FOR: Cleveland RFI 230	JOB NO: 49633	SHEET NO:
MADE BY: LER	CHECKED BY: KDG	BACKCHECKED BY:
DATE: 2/1/12	DATE: 2/2/12	DATE:

Issue: Column bars 3PF1101 along one 15'-4" face of Ramp A5 Pier 3 column have been set out of place. The line of bars has been set 7" clear from the face of the column. Per RFC plans, the clear distance to the #11 bars should be 4 1/2". The 3PF1101 bars on the opposite side were placed correctly.

(2) Additional Steel Detail

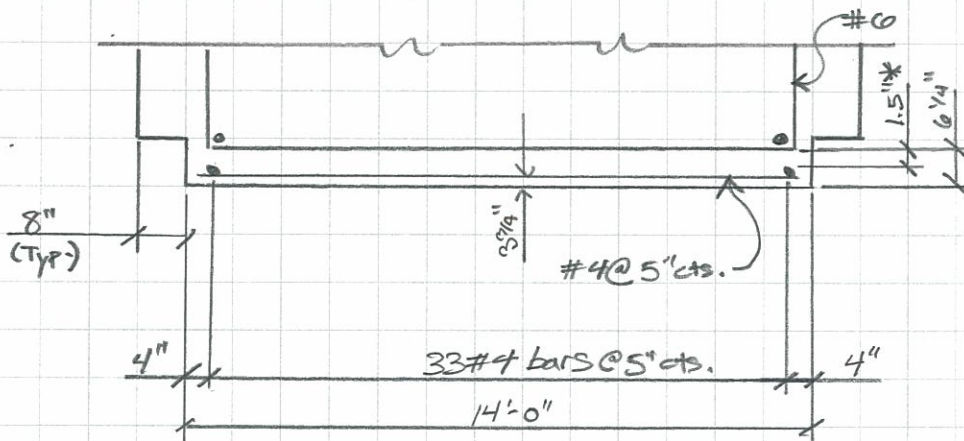
Provide additional steel at outside face for T&S.

$$A_s \geq \frac{1.3 bh}{2(b+h)f_y} \quad (in^2/ft)$$

$$0.11 \leq A_s \leq 0.60$$

$$b = 60"$$

$$h = 14' \rightarrow 168"$$

$$A_s \geq \frac{1.3 (60)(168)}{2(60+168)(60)} = 0.48 in^2/ft$$

Use #5 @ 7" \Rightarrow 0.53 in²/ft
 OR #4 @ 5" \Rightarrow 0.48 in²/ft

* min. bar spacing = 1.5"
